MEMORANDUM

SUBJECT: SF-19-009– Retreat at Timber Ridge Filing 1  
Second Submittal

RETREAT AT TIMBERRIDGE FILING NO. 1  
CONSTRUCTION DRAWINGS  
TITLE SHEET

RETREAT AT TIMBERRIDGE FILING NO. 1  
CONSTRUCTION PLANS  
STREET IMPROVEMENT PLANS  
ANTELOPE RAVINE DR. & HAWK HILL CT.

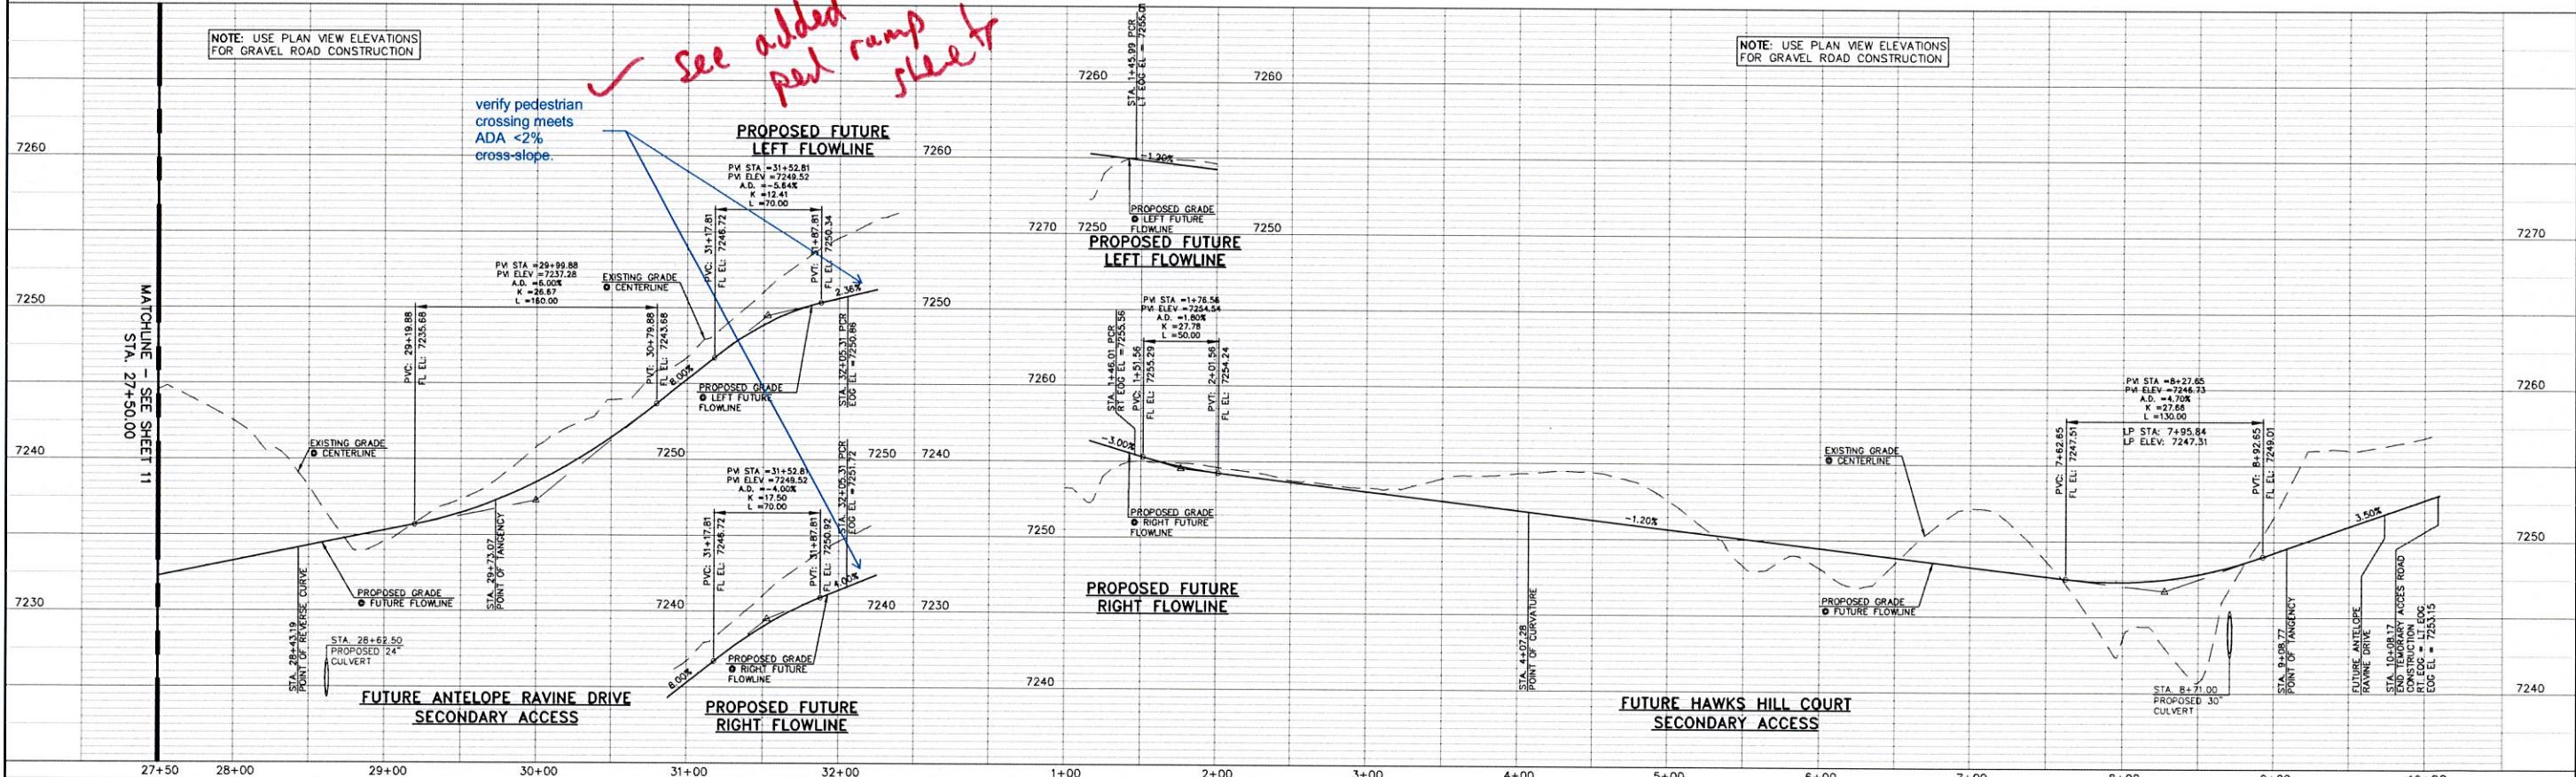
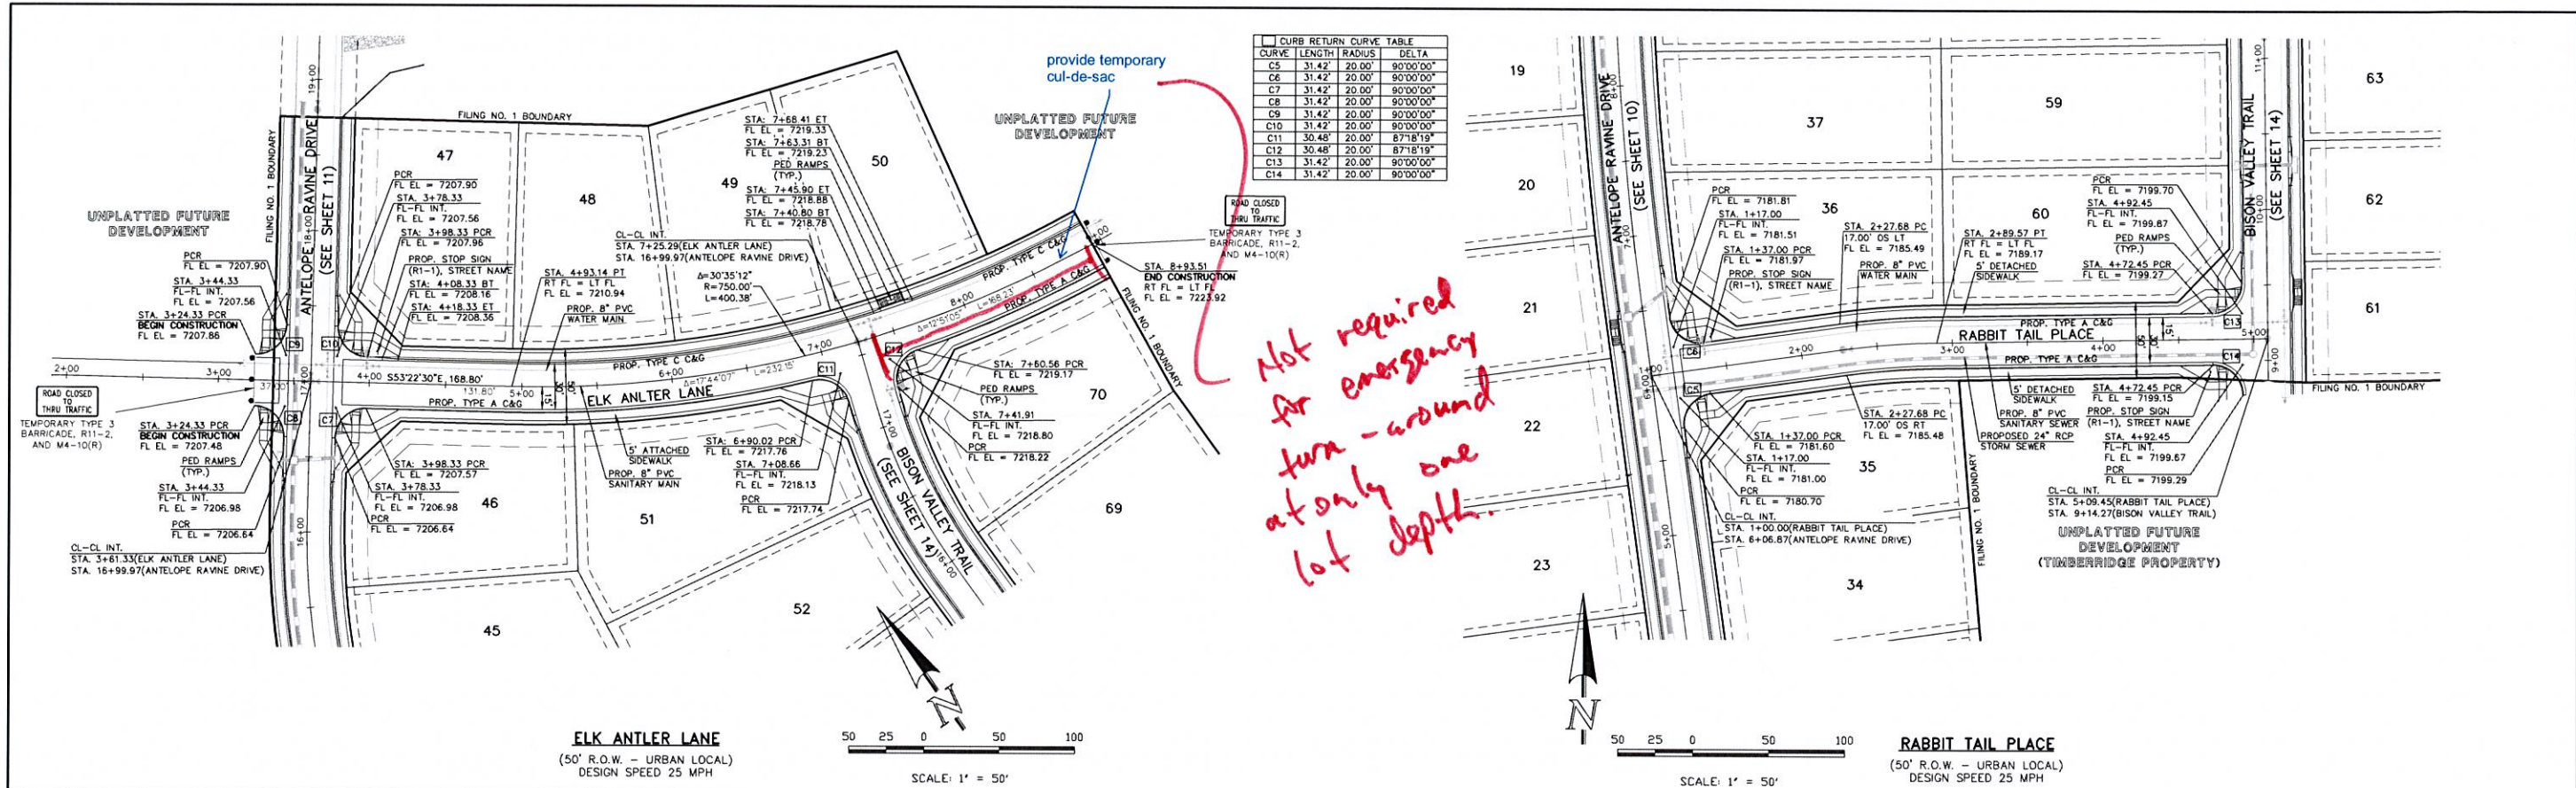
verify pedestrian crossing meets ADA <2% cross-slope.

*See added red ramp sheet*

DATE: 04-05-19  
 SHEET: 13 OF 29  
 JOB NO.: 1185.00

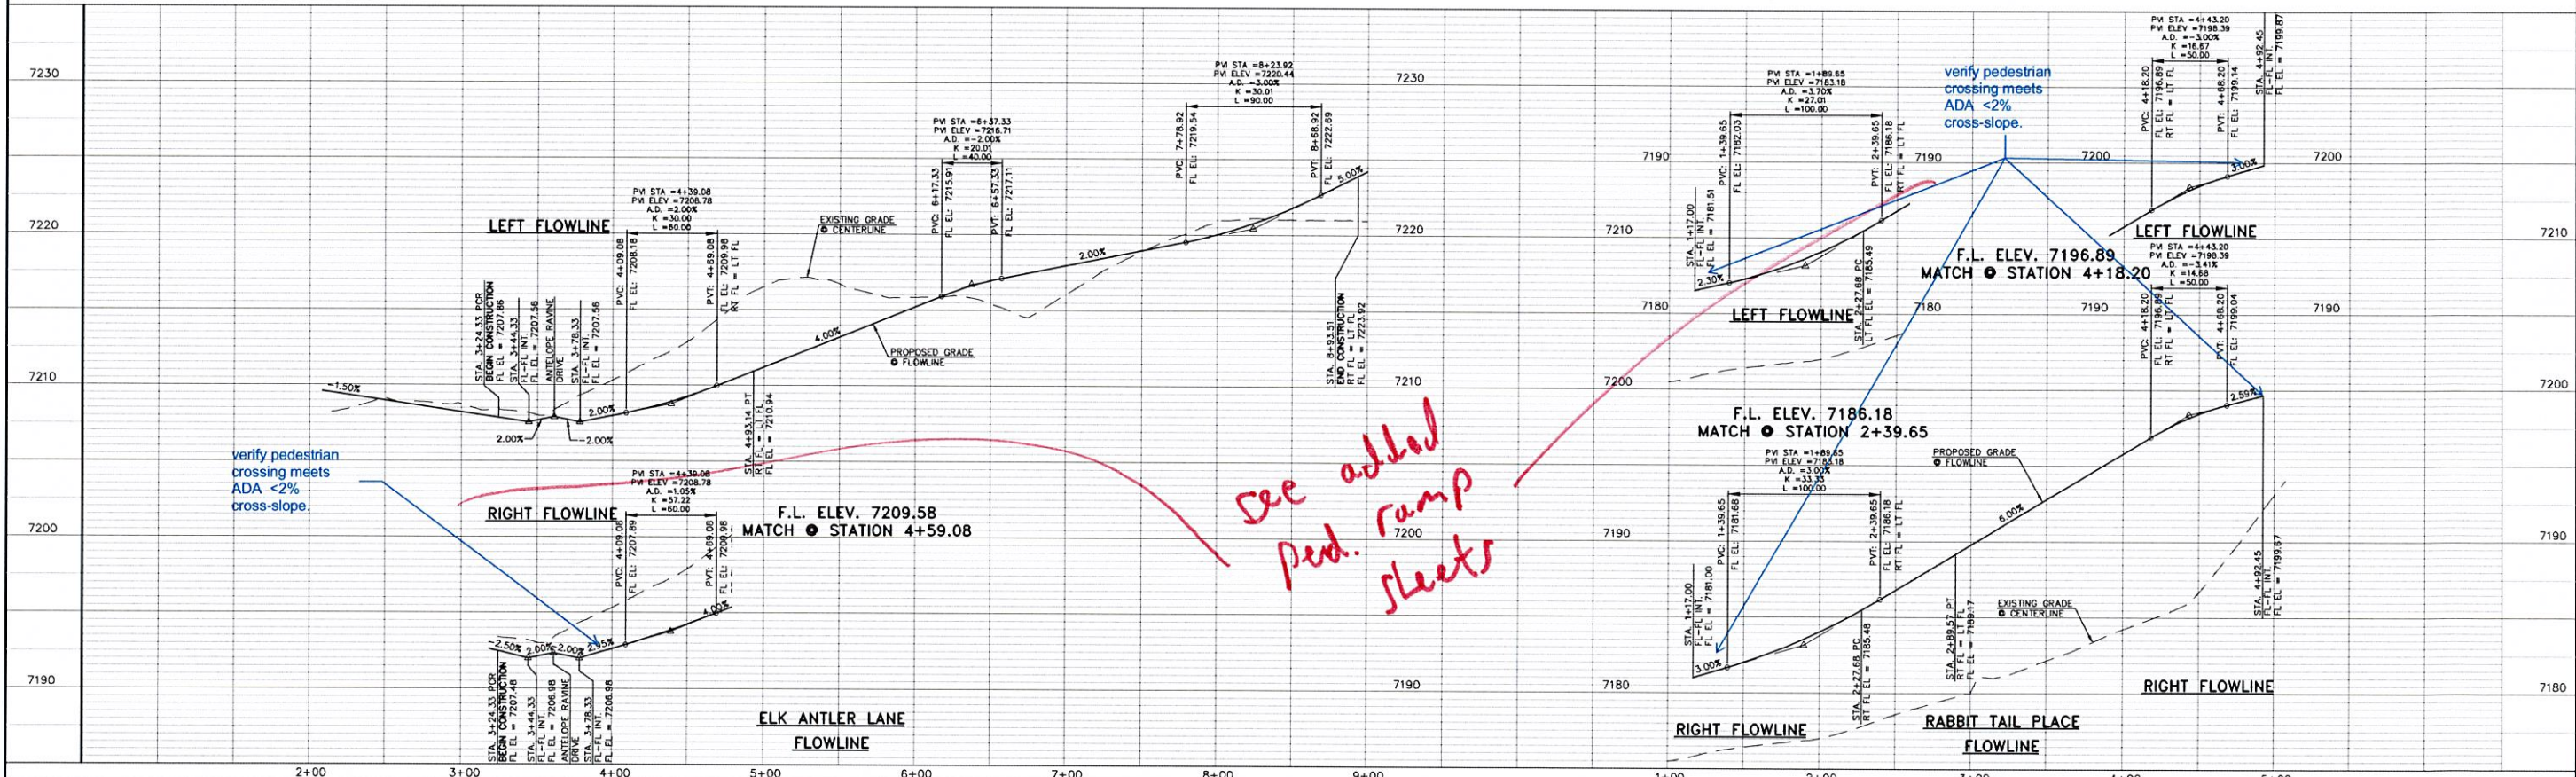
*verify pedestrian crossing meets ADA <2% cross-slope.*

*verify pedestrian crossing meets ADA <2% cross-slope.*

*see added ped. ramp sheets*

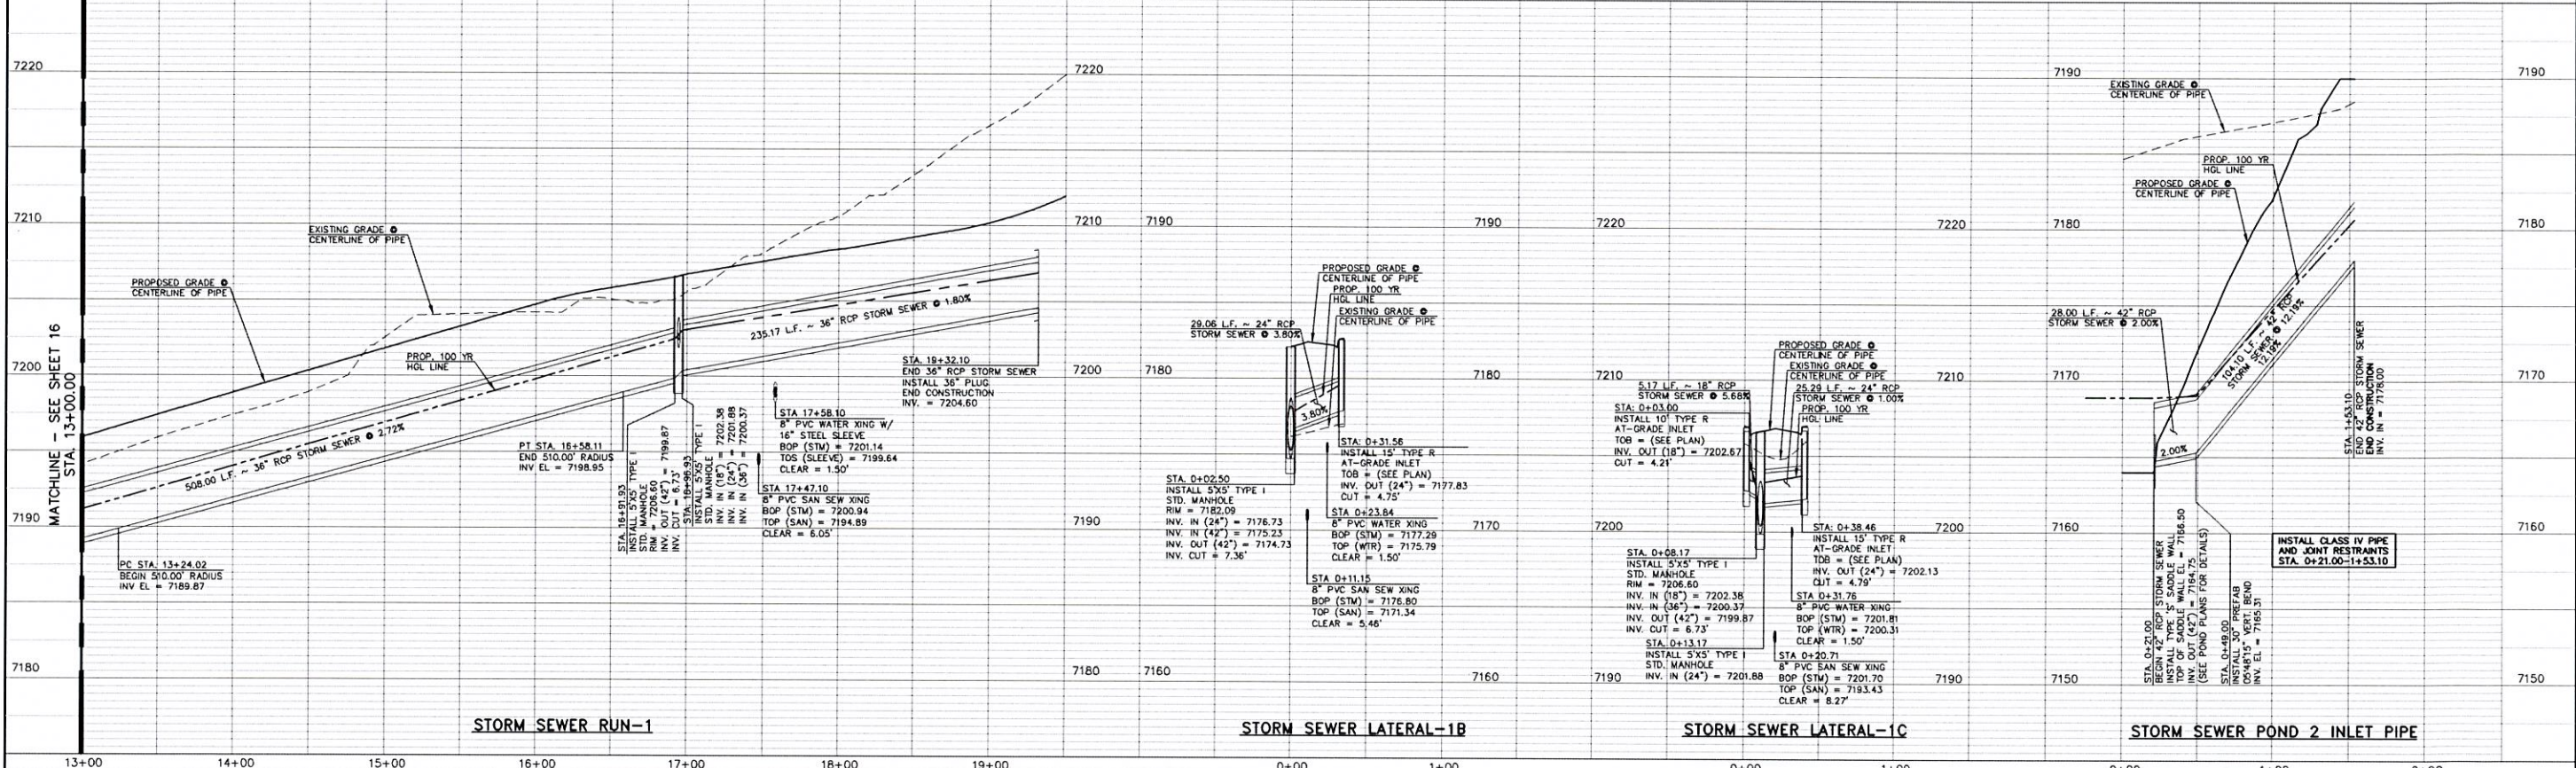
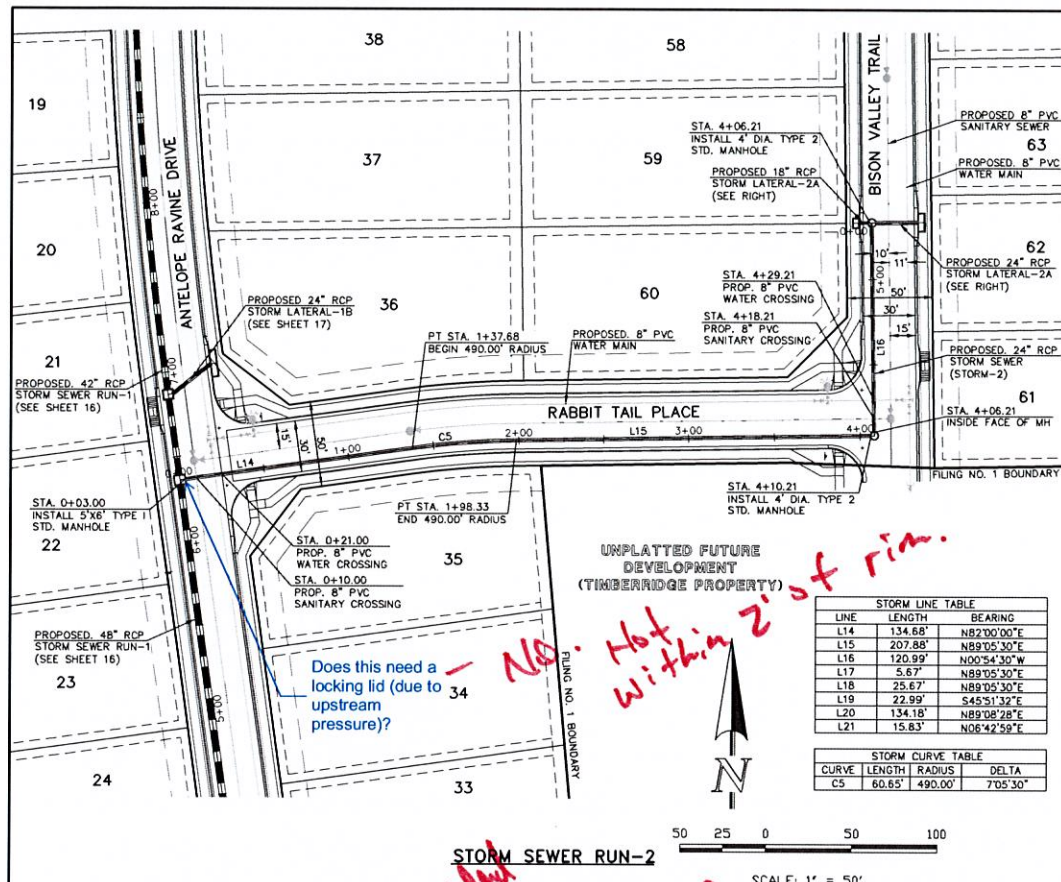
Label all storm sewers as public or private/metro district

**STORM SEWER LATERAL-3A**  
SCALE: 1" = 50'

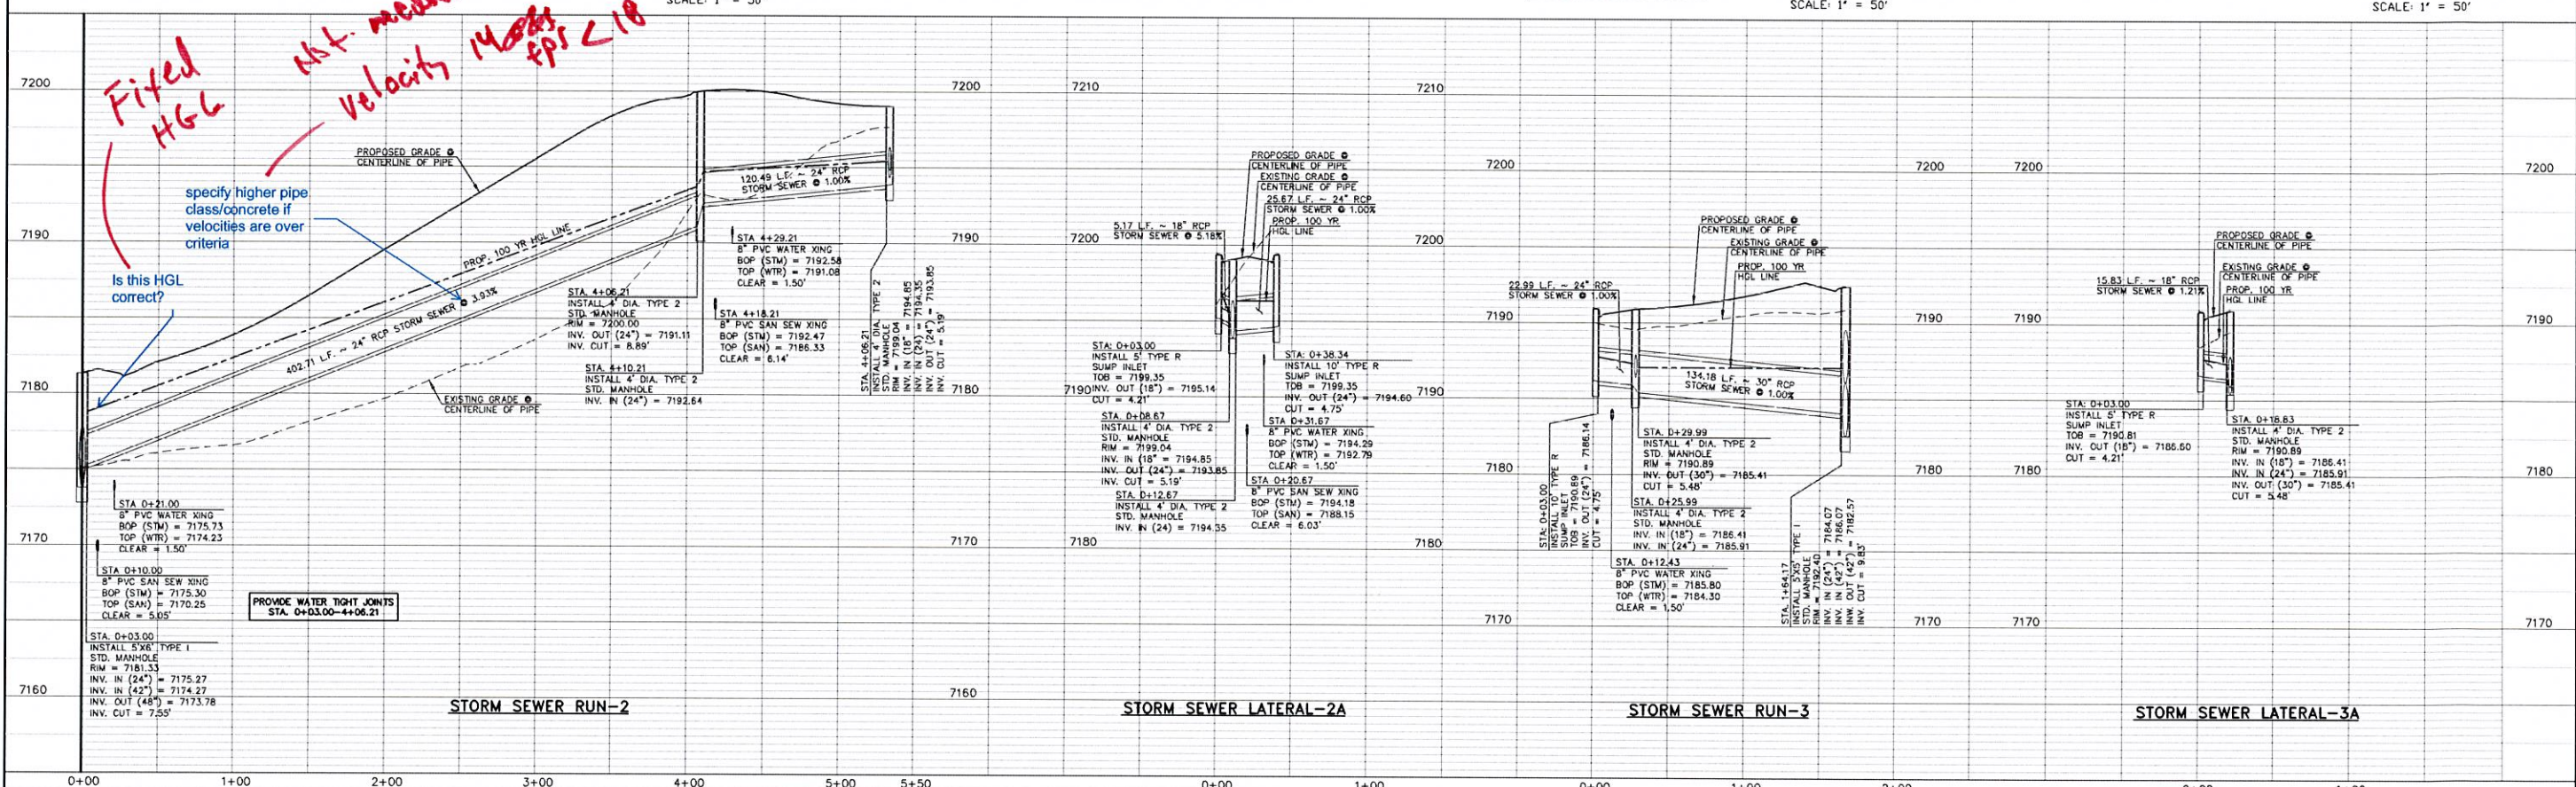
Is this HGL correct?
